**RE: Responses to USACE February 23, 2018, Data Request  
New England Clean Energy Connect Project  
Application for Department of the Army Permit**

**Response to the  
February 23, 2018  
USACE Information Request**

*Prepared for:*  
**Department of the Army**  
**New England District, Corps of Engineers**  
**Application No. NAE-2017-01342**

**Representative Cross Section  
from Quebec Border to  
The Forks Plantation**

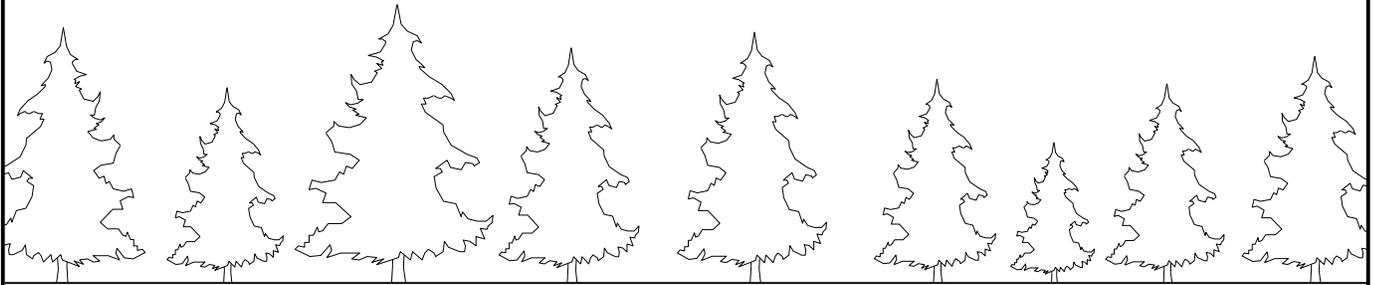
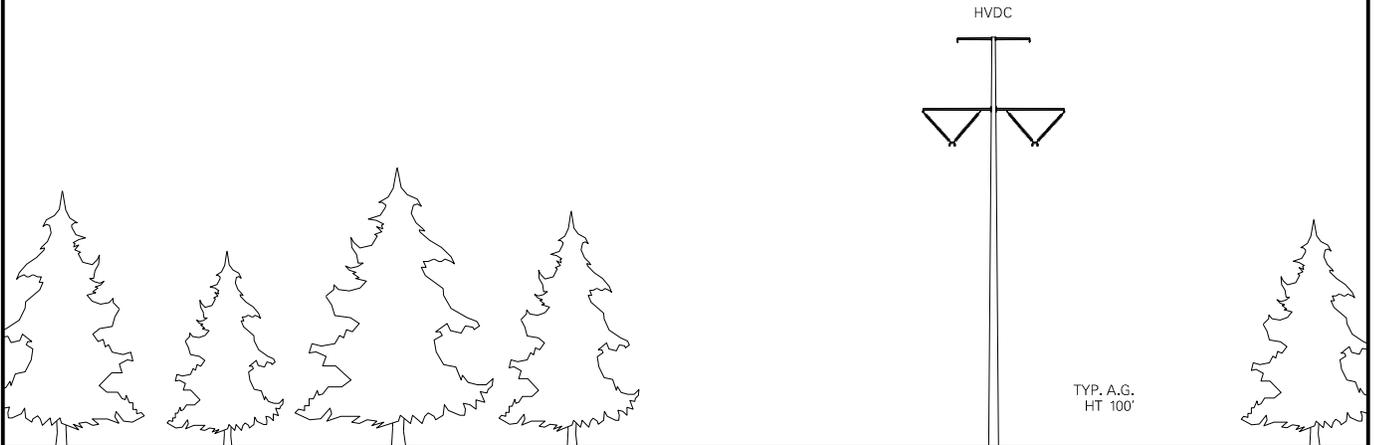
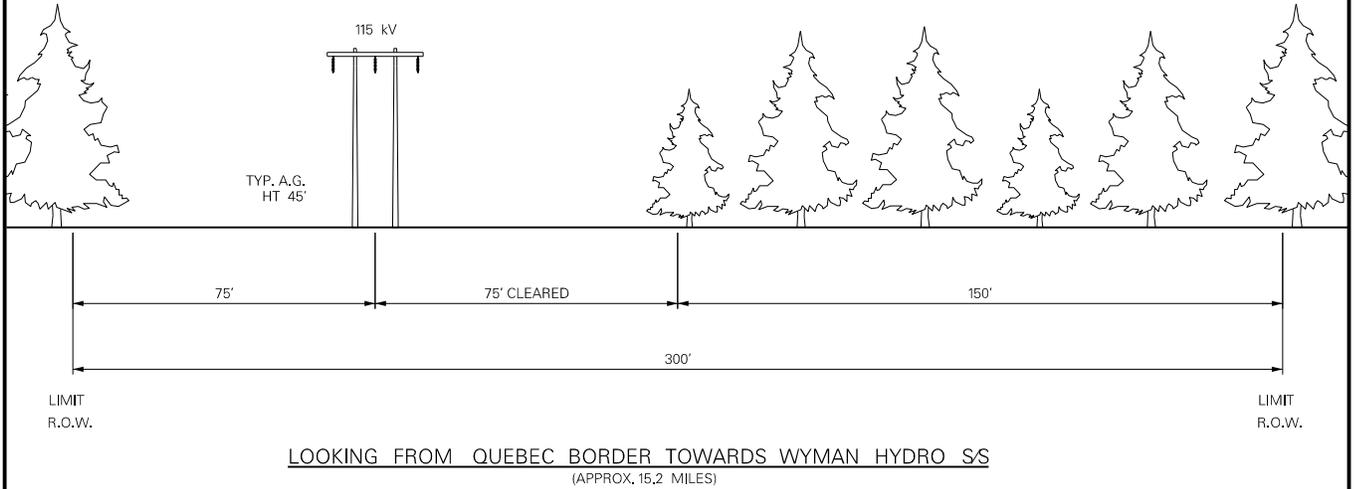
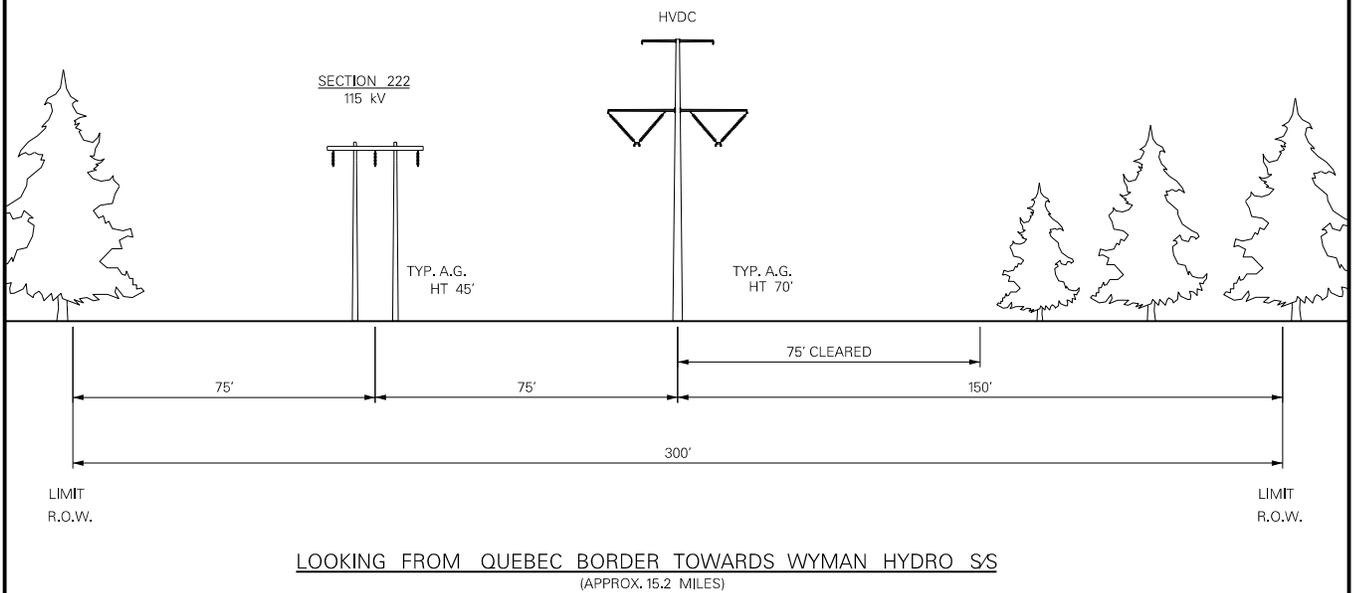
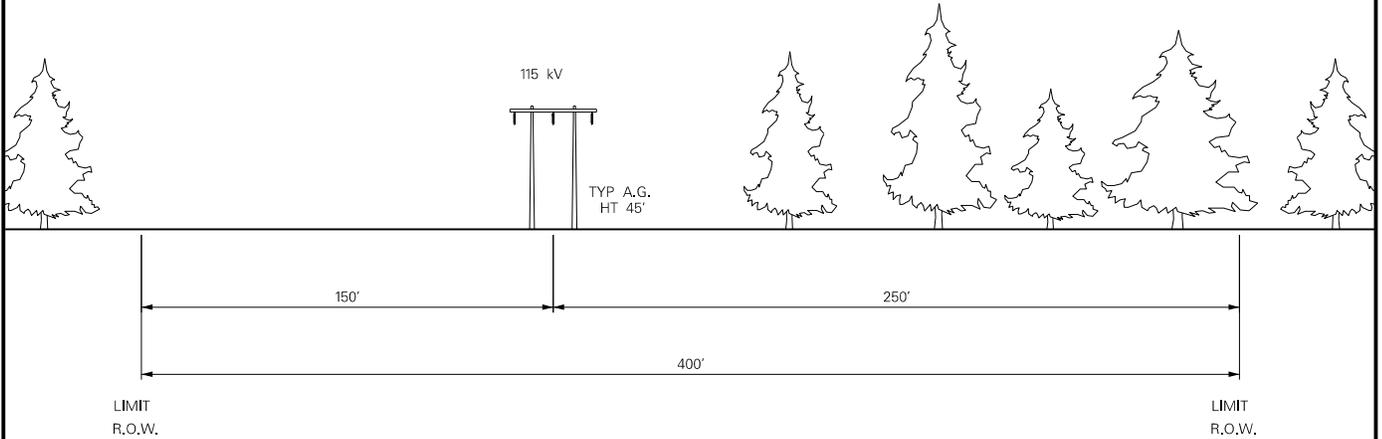
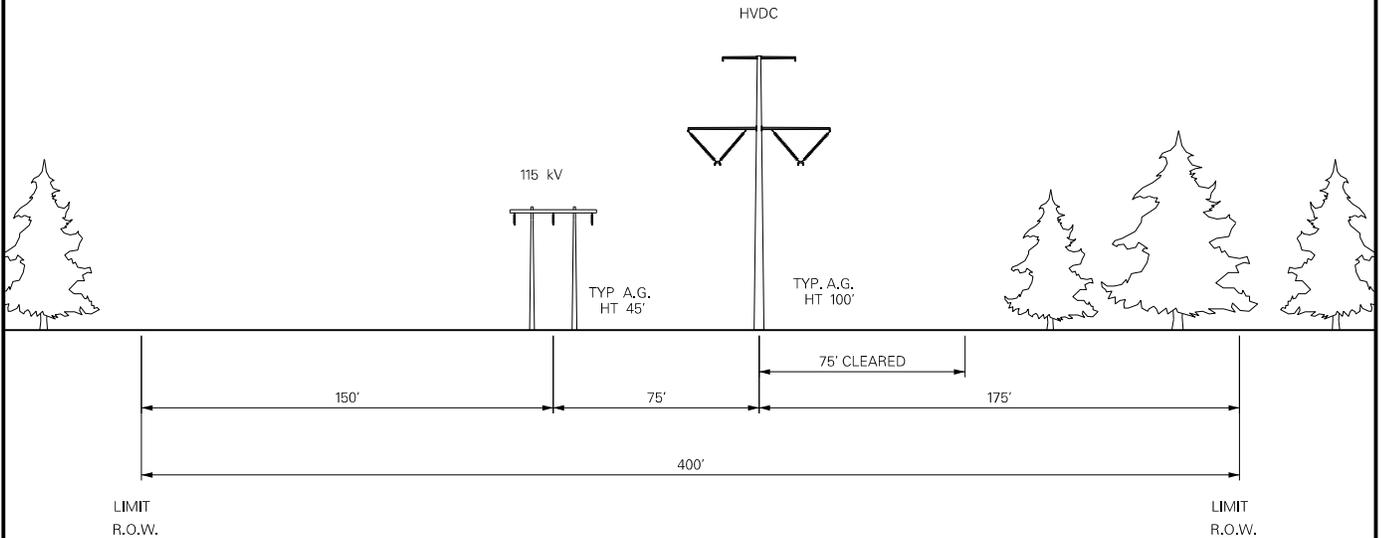
**22. Can the various sections be consolidated to a more limited number of 'typical' sheets for purposes of our future public notice? Can you also provide a generic web link that we can add to our public notice that would allow the public to view plans specific to their region or location of interest?**

As discussed with Jay Clement (USACE) on March 15, 2018, a subset of representative cross-sections, like those used in the public information meetings hosted by CMP, is included in Attachment D.

**New England  
Clean Energy Connect  
Border Crossing Plan**

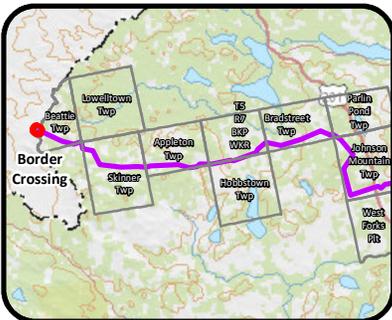
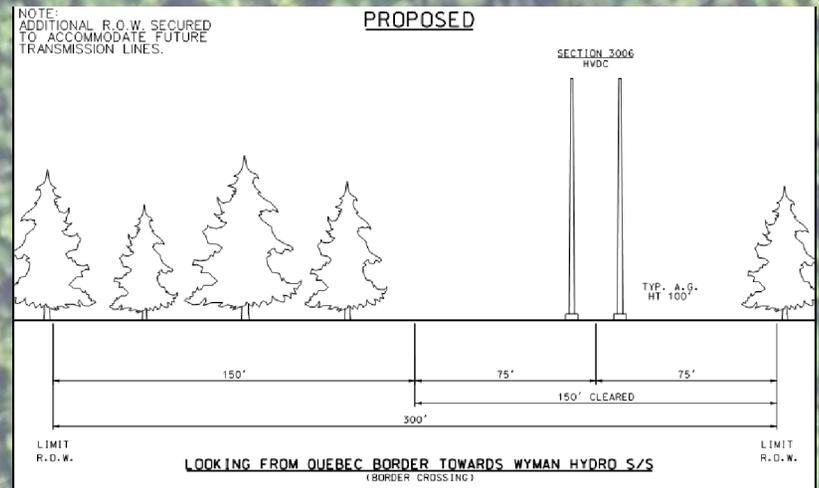
**23. The Corps requires a more detailed set of plans for the border crossing. This is a requirement for our process, for our combined review with the Dept. of Energy (DOE), and for the review that must be conducted by the International Joint Commission.**

Please see the border crossing plan provided in Attachment D. CMP will update this plan with additional details if requested by the USACE or the DOE.

**Attachment E: USACE New England District Construction Mat BMPs**

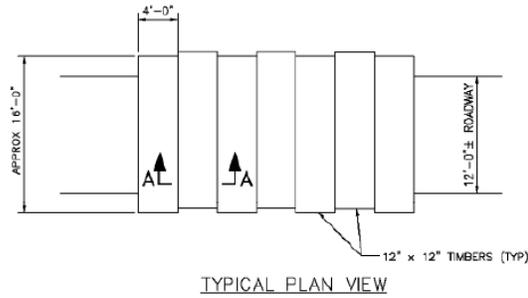
**24. Please provide a 'typical' plan of a stream crossing using mats as well as a wetland crossing. If culverts or other measures will be used to insure wetland cross drainage or downstream flows, the section should show that.**

CMP will adopt the USACE New England District Construction Mat Best Management Practices (BMPs) and example typical figures included in Attachment E, and will require construction contractors to implement these BMPs. In addition, CMP will implement the BMPs for the use of construction mats included in Exhibit 10-1 and Exhibit 10-2 of the Site Law application. CMP is proposing to construct the Project with no in-stream construction activity. In the event atypical conditions necessitate the installation of a culvert, CMP will request a variance from the USACE and will not proceed without agency approval. The variance request will include a site-specific plan for the crossing that identifies the bank to bank width and other stream characteristics, photos of existing conditions at the crossing location, proposed culvert size, the anticipated duration that the culvert will be in place, and the restoration measures that will be implemented upon its removal.
